STAFF REPORT  
KETCHUM PLANNING AND ZONING COMMISSION  
MEETING OF May 20, 2026

PROJECT: Wood River YMCA (Addition)

FILE NUMBER: P25-068A

APPLICATION: Design Review

Figure 2 Building Materials Sheet A4.0

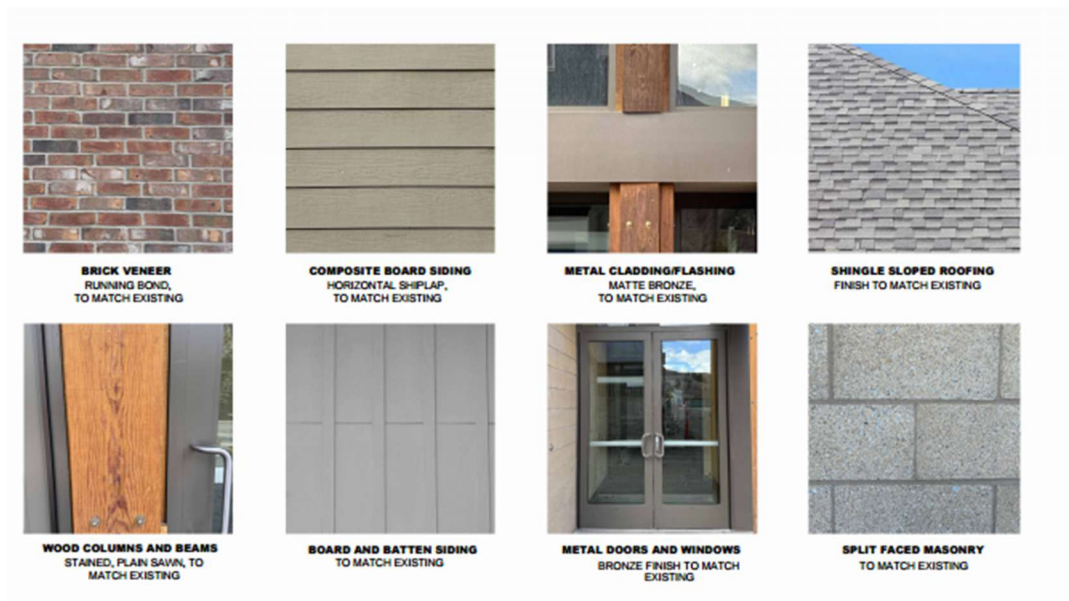
The materials proposed on the submitted project plans *Exterior Renderings* (A5.0, A5.1) and the *Building Elevations and Materials* sheets (A4.0& A4.1) match the existing structural materials including the shingled roof, brick, horizontal board siding, metal finishes, wood columns and beams, masonry, board and batten, and the existing metal and glass doors. The colors of the proposed materials are designed to match the

existing building therefore the addition would appear to be fully integrated into the existing architectural palate and materials. Signage on the building is not proposed to change however staff has added a suggested condition of approval in case the signage plan changes. Staff suggested Condition of Approval: A Sign Permit is required for any new signage or banners displaying or advertising the facility. (KMC 16.05) During the Pre-Application Design Review the Planning and Zoning Commission requested the applicant revise their garage door design. Originally a more utilitarian garage door painted a bronze color, the applicant has revised the design and now faced the door with wood and trim and kept the glazing windows on top so it appears more residential. In addition, the Commission asked for more lighting for safety be added on the back side of the building. The applicant added four full cut off wall mounted sconces on the proposed rear of the structure. ( See Attachment B: Sheet A.7)

**SITE, GRADING, & DRAINAGE PLAN**  
**WOOD RIVER COMMUNITY YMCA EXPANSION**  
 LOCATED WITHIN T.4 N., R.17 E., SECTIONS 12 & 13, B.M., CITY OF KETCHUM, BLAINE COUNTY, IDAHO  
 PREPARED FOR: RLB ARCHITECTURA

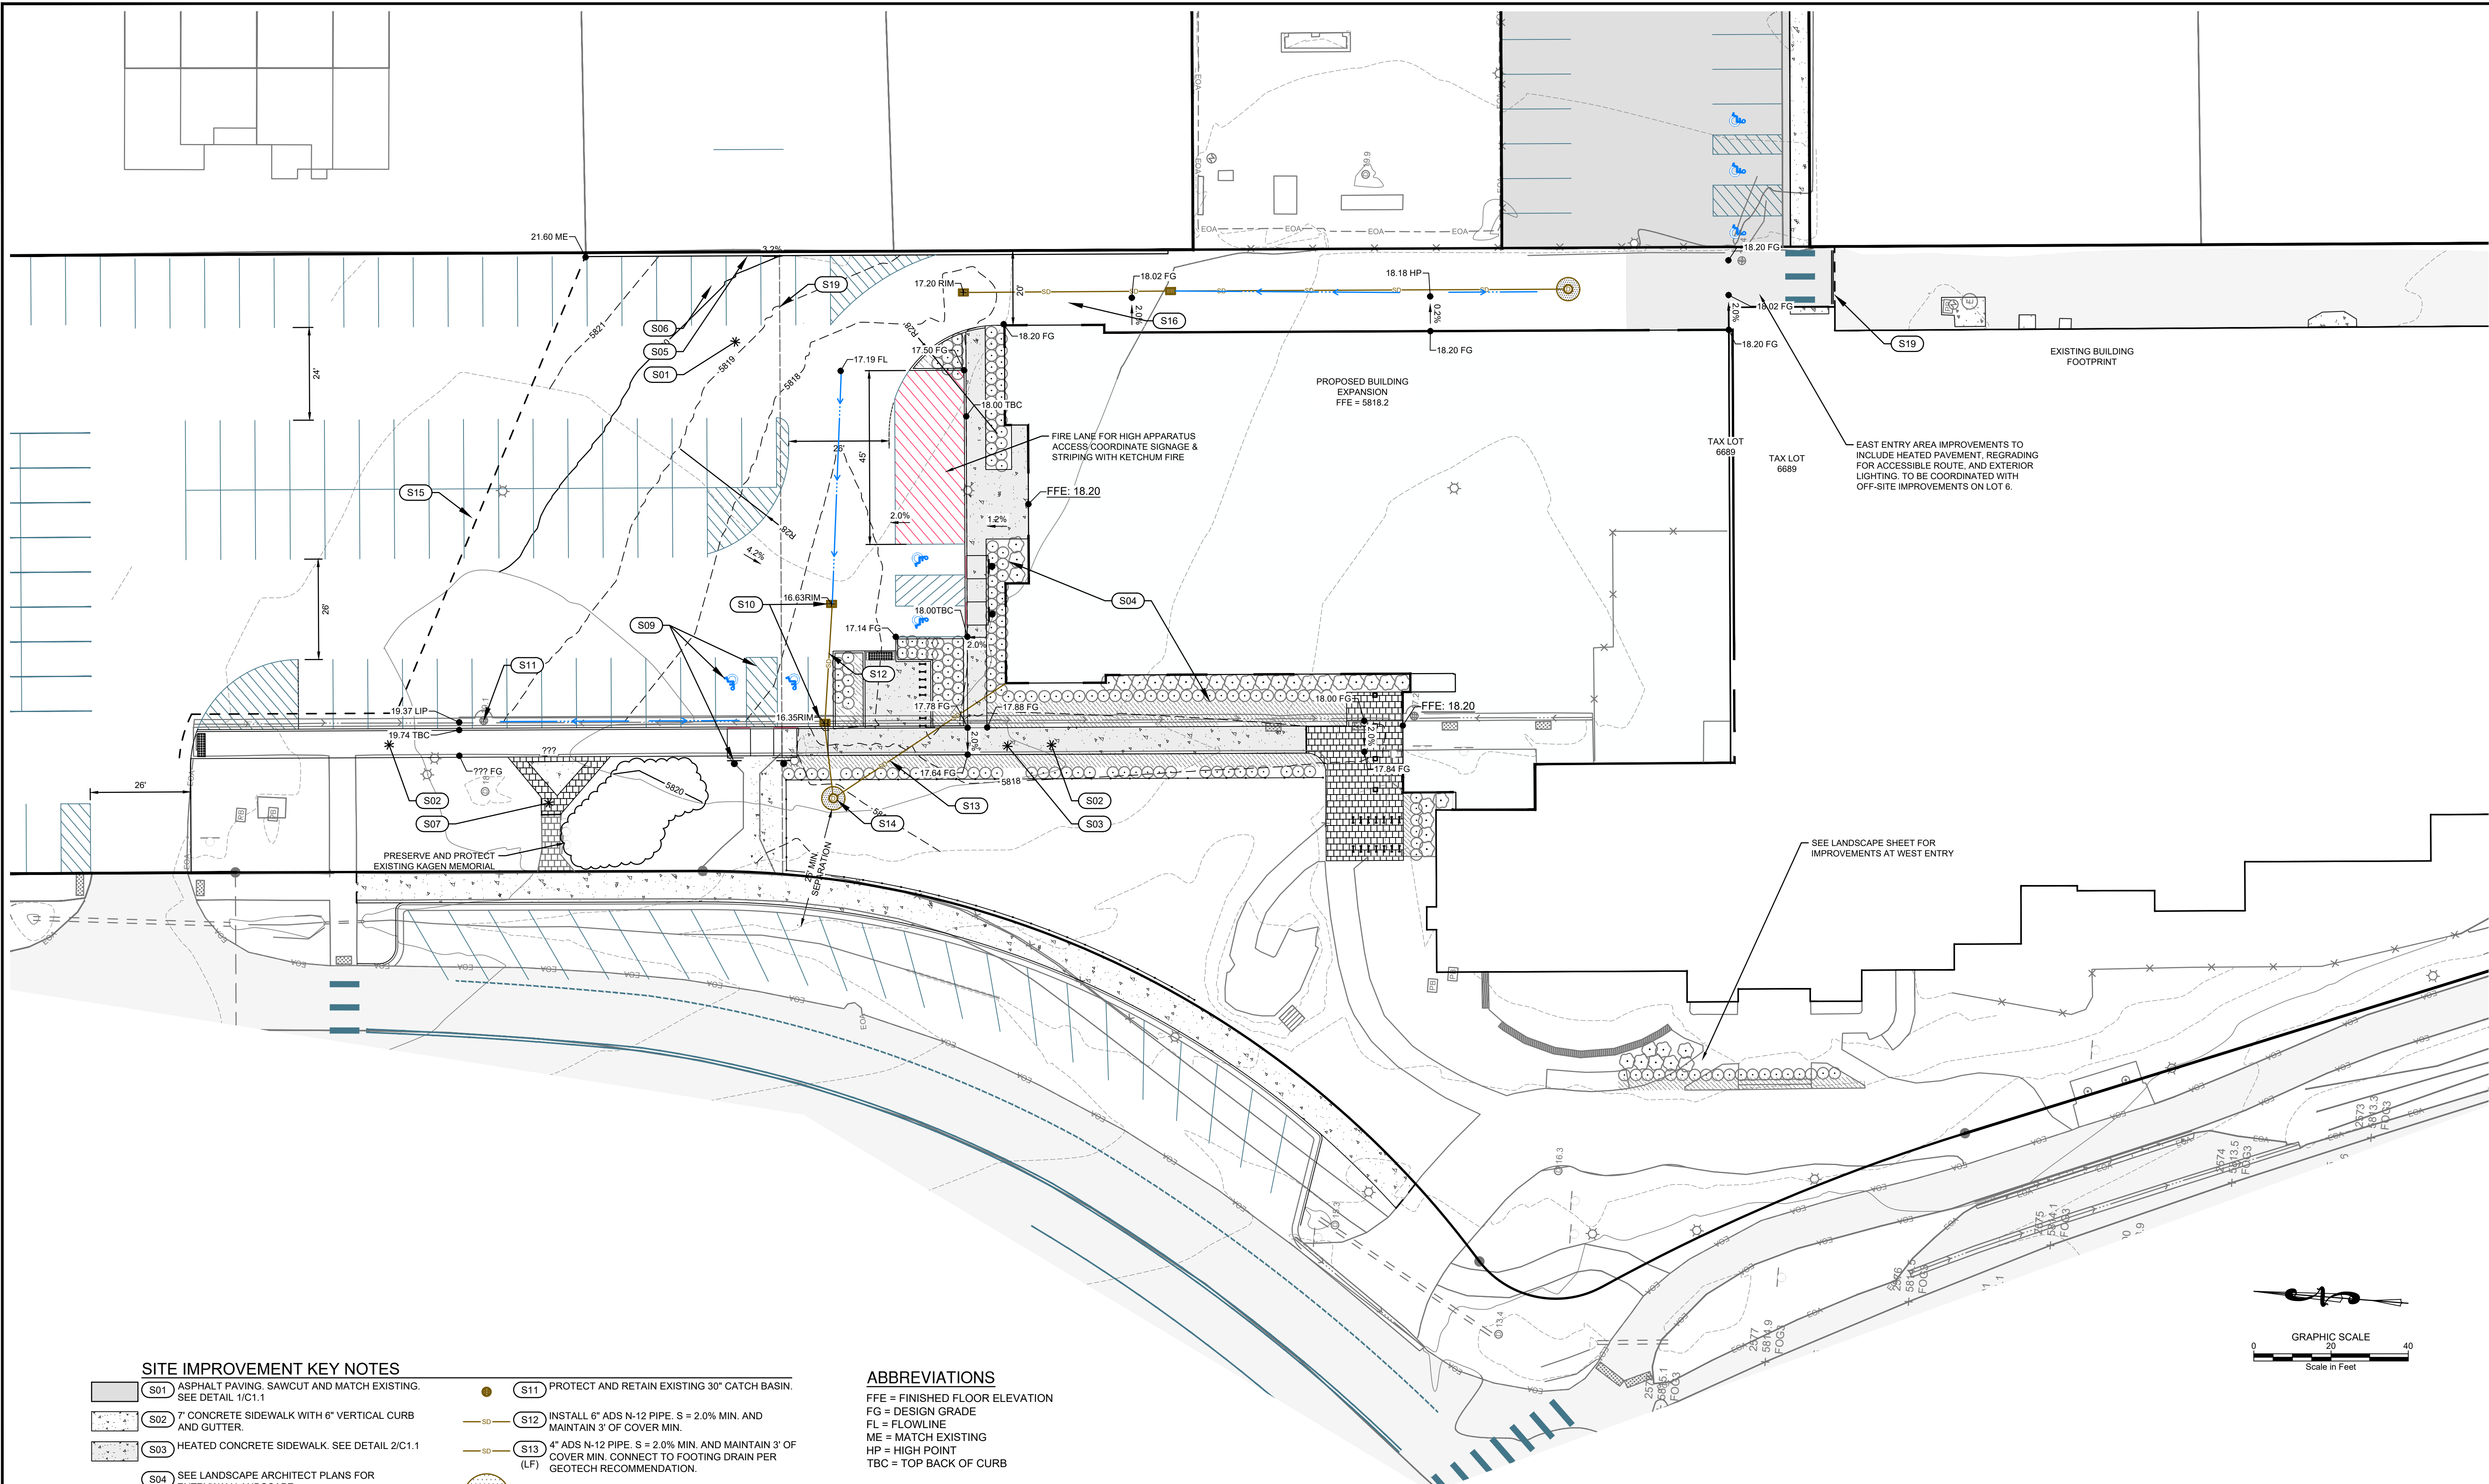
**KMC 17.96.060 C. Drainage:** Standards 1-5 listed below have all been met and reviewed by City Engineer. (See Attachment B: Sheet C1.0)

The Site Plan on Attachment B: Sheet C1.0 shows unobstructed access for fire and emergency vehicles. A fire lane of 26' hugs the northern portion of the structure and tapers to ~20' when servicing the rear of the structure. A siren activated gate is shown on Attachment B: Sheet A1.1. which could be accessed by emergency vehicles however a snowplow or other service vehicles would not be able to utilize this portion of

the alley and would have to back up quite aways in leu of a turnaround. Staff suggest a condition to change the siren activated gate to a manual obstruction to meet the need for both detracting passenger vehicles to and from the Lot 6 parking area but still allowing for the circulation of service vehicles when necessary. For example, a chain/roped off gate or something similar.

5. The siren activated gate shown within the plan set shall be replaced with a manually removable obstruction for access by service and snow removal vehicles.
6. In addition to the requirements set forth in this Design Review approval, this project shall comply with all applicable local, state, and federal laws.

**LANDSCAPE PLAN**

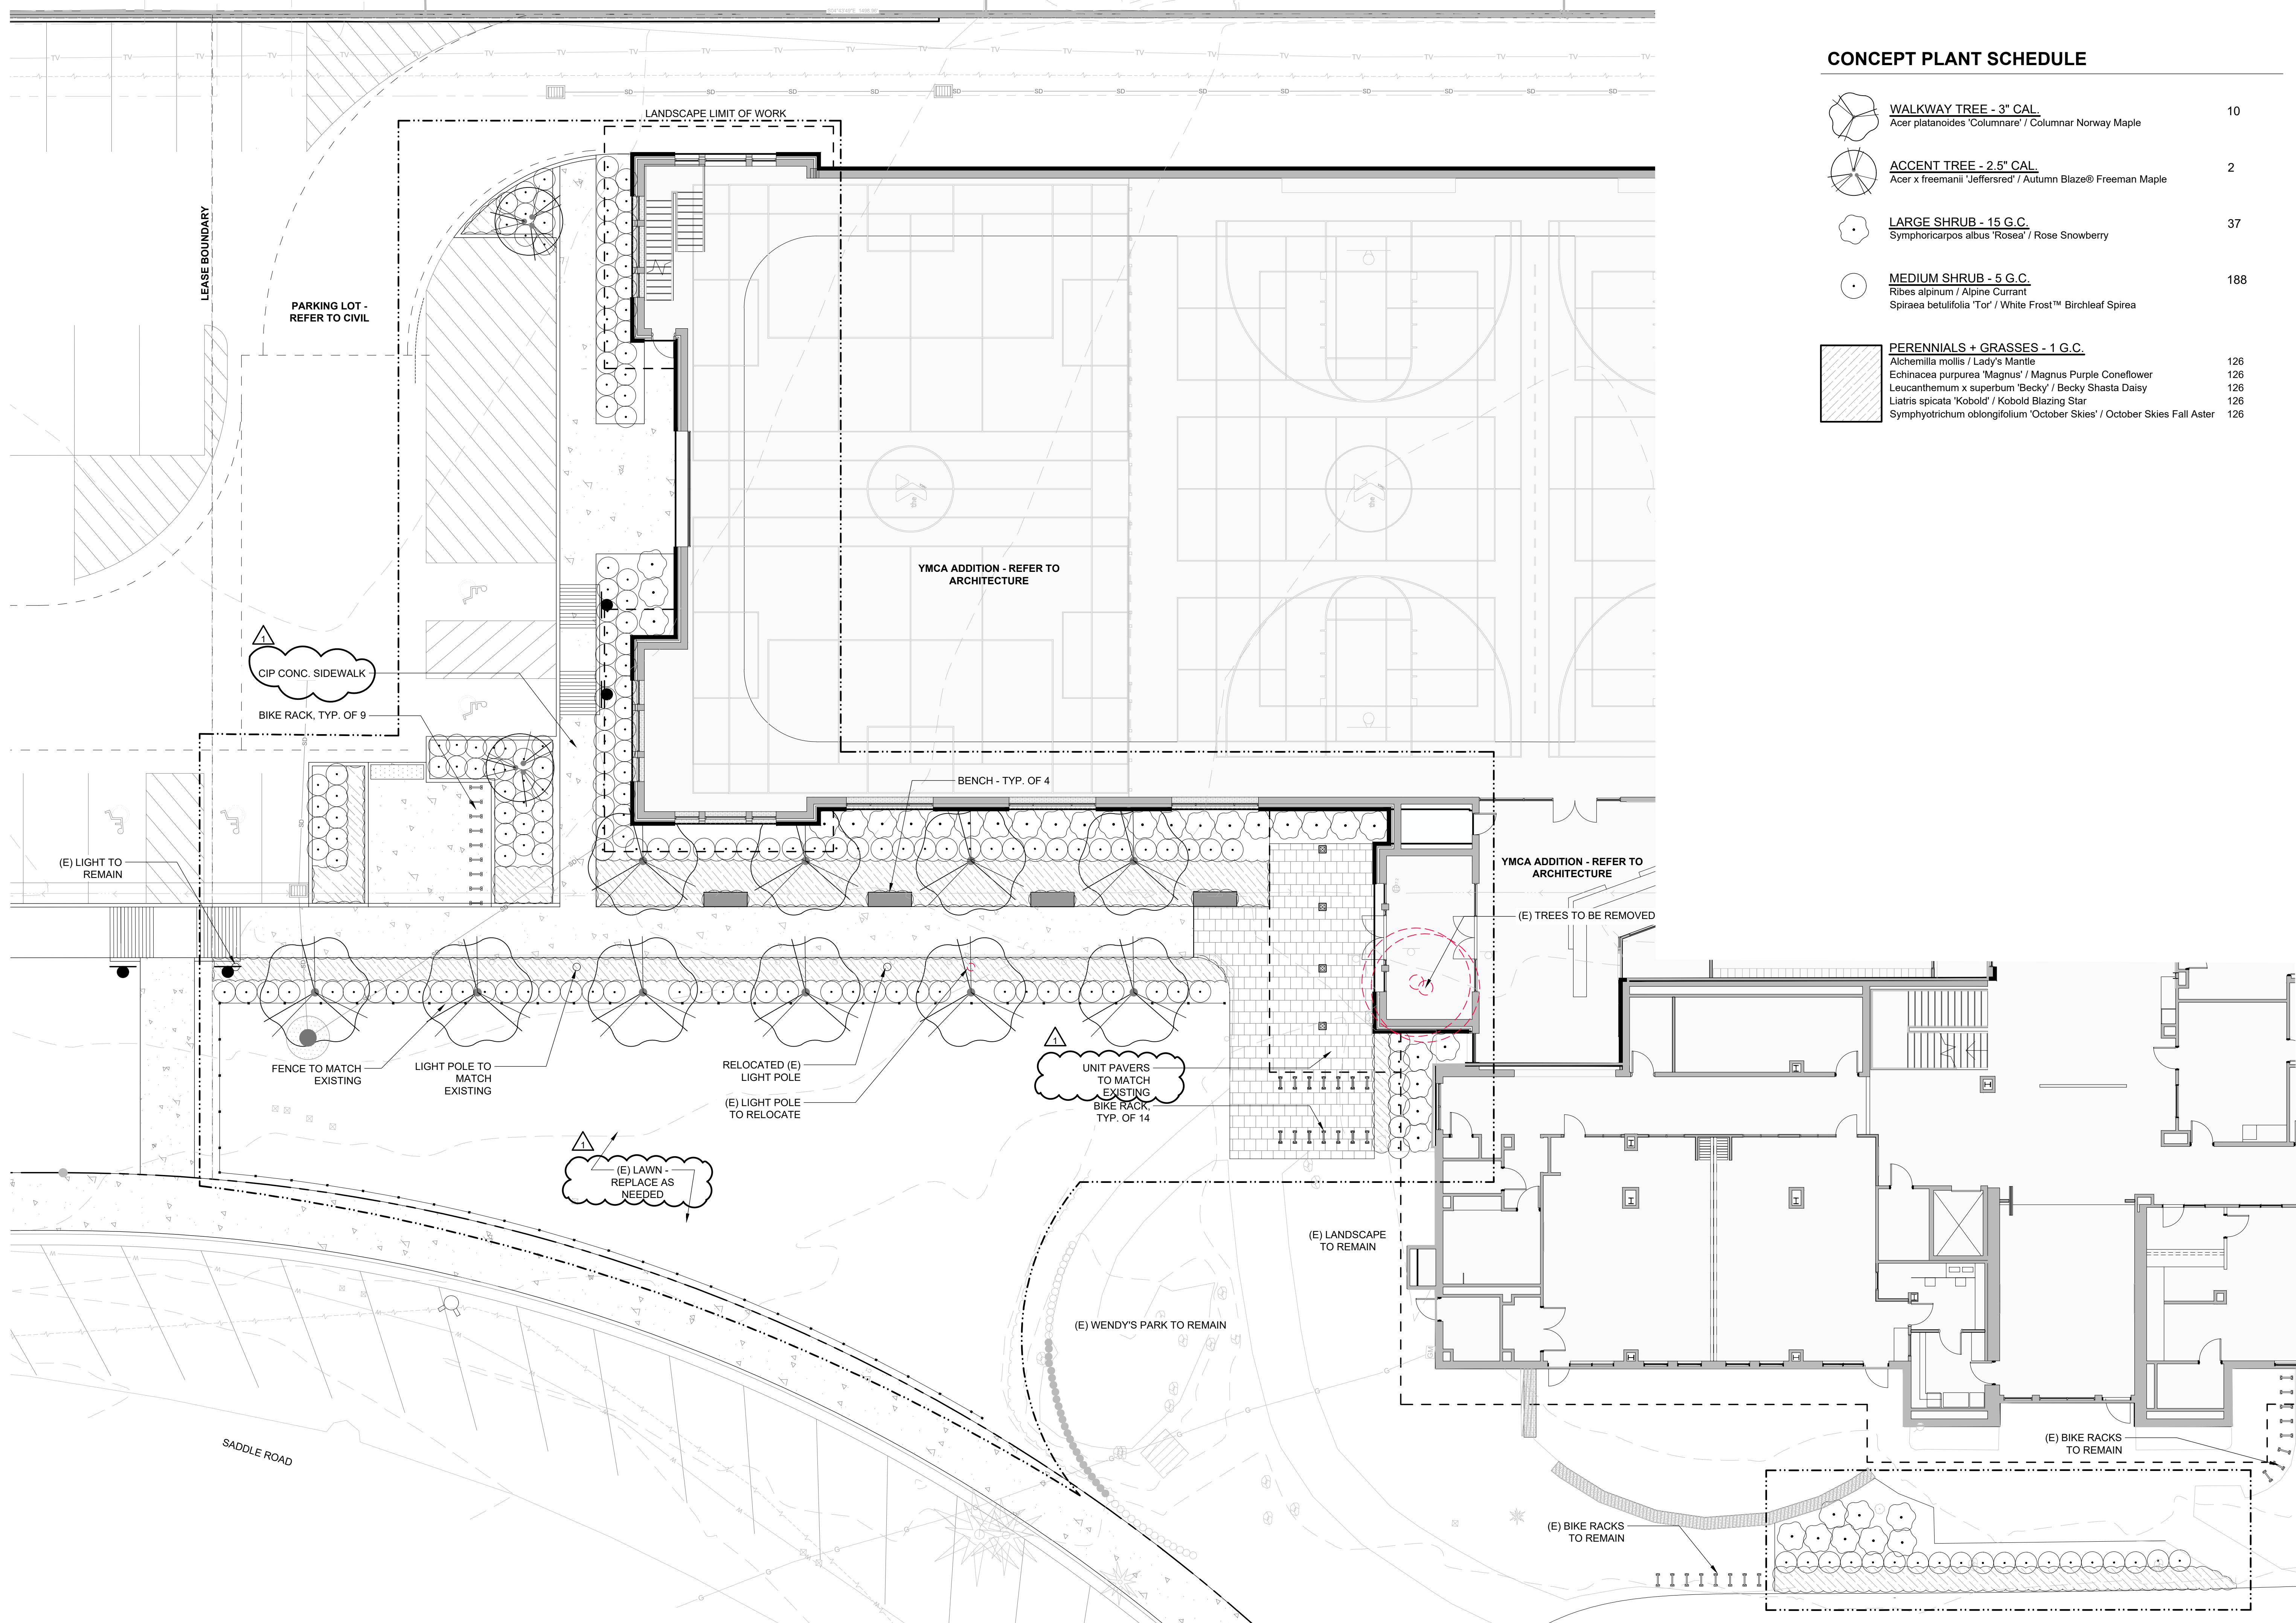
Attachment B: Sheet L.1 shows that the applicant is proposing to match existing fencing, utilize pavers to match existing, and add uniformity with plant groupings.

The landscaping standards appear to be met. The applicant has sited the landscaping adjacent to the structure and hardscapes to create a buffer. In addition, a new landscaped portion is proposed to buffer the front area where the removal of the stairs is proposed. Sixteen existing bike racks will remain at this western portion of the building and 14 more proposed at the new main lobby paver area. (See Attachment B: Sheet L.1) The new proposed entranceway is flagged on either side of the walkway with deciduous ornamental maples trees which will both provide shade in the summer and color in the fall. In addition, the vegetative height will help break up the mass of the facade facing Saddle Road and Warm Springs views of the building.
